MEMORANDUM

SUBJECT: Inspiration Subdivision – Pond 1 Revisions (CN 651183)

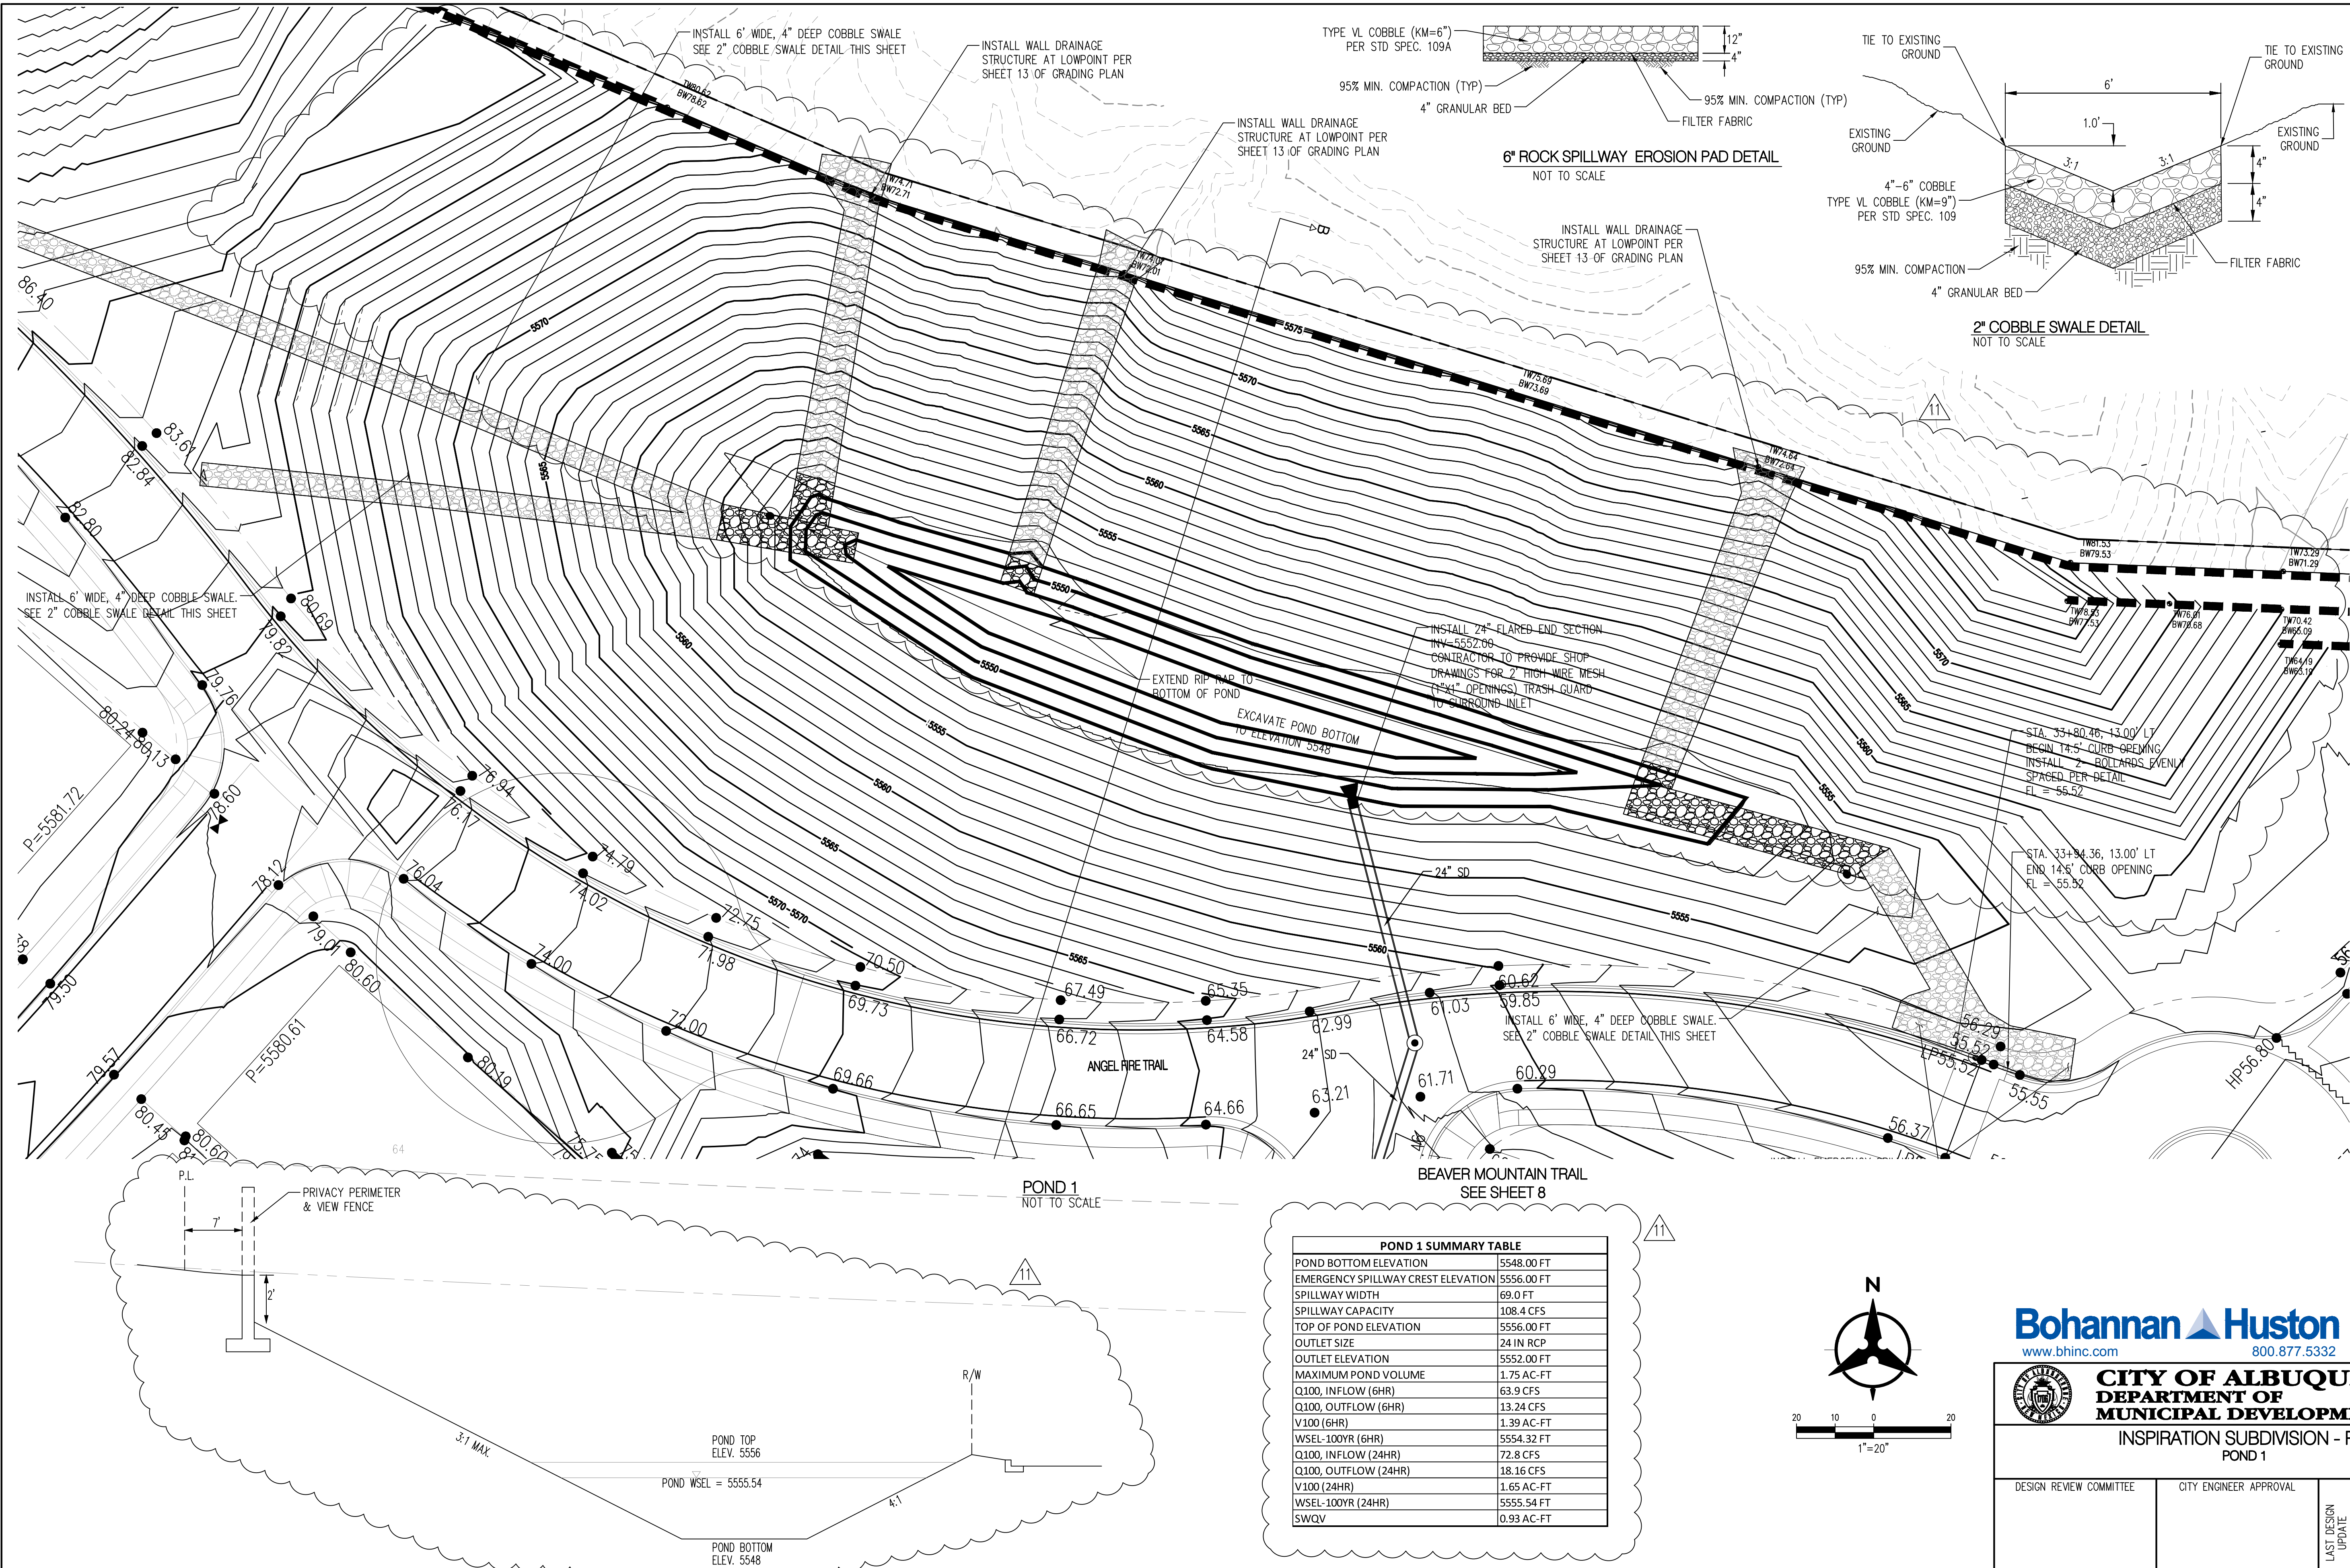
The intent of this memorandum is to notify the City of Albuquerque Hydrology Section of an as-built condition within the Inspiration Subdivision that varies from the original design and approved drainage report. Bohannon Huston, Inc. received as-built survey information for the Pond 1 constructed within the Inspiration Subdivision as part of Phase 1A. Due to grading constraints on the north side of the pond, the as-built survey indicated that the pond volume was less than the volume required in the approved drainage report. BHI has re-evaluated the hydrologic and hydraulic models for the system and has recommended grading modifications to ensure the appropriate pond and downstream storm drain performance, per the City of Albuquerque Design Process Manual.

The original pond design provided 2.41 acre-feet of storage with a bottom elevation of 5550.00 feet and a top (spillway crest) elevation of 5556.00 feet. The pond outlet was designed to be 2.0' above the pond bottom to create a stormwater quality volume below the outlet (0.8 acre-feet). The as-built data indicated that the pond bottom and spillway elevations were constructed per plan, but the grading constraints along the north side of the pond results in a resultant volume of only 1.54 ac-ft. This grading information was incorporated into the HEC-HMS model for the project. Under these conditions, the pond failed by overtopping during the 100-year, 24-hour storm event. As such, BHI developed alternative solutions to ensure the pond functions as the original design intended.

BHI recommends excavating the pond bottom an additional 2.0 feet (proposed bottom elevation of 5548.00 feet), while leaving the outlet pipe and spillway unchanged. This will increase the total pond storage to approximately 1.80 acre-feet and increase the stormwater quality volume below the outlet pipe to be 0.93 acre-feet (see attached Grading Plan and Stage-Storage information). These changes will still allow the 100-year, 24-hour water surface elevation (WSEL) to be approximately 6 inches below the emergency spillway crest elevation. With the changes in the WSEL, the effective headwater increases, which increases the discharge out of the outlet pipe to the downstream storm drain system. As such, BHI backchecked the hydraulic grade line (HGL) analysis for the impacted storm drain system. Using the previously approved hydraulic model (Stormwater Studio) that applies the current HEC-22 methodology, the HGL was shown to still be below any of the top of grate elevations and the energy grade line (EGL) shown to be within the right-of-way. The following table summarizes the changes to the Pond 1.

This data will be included in the as-built record drawings for the project. Attached is the 100-year HGL results (including the model plan and profile) from Stormwater Studio analysis software.
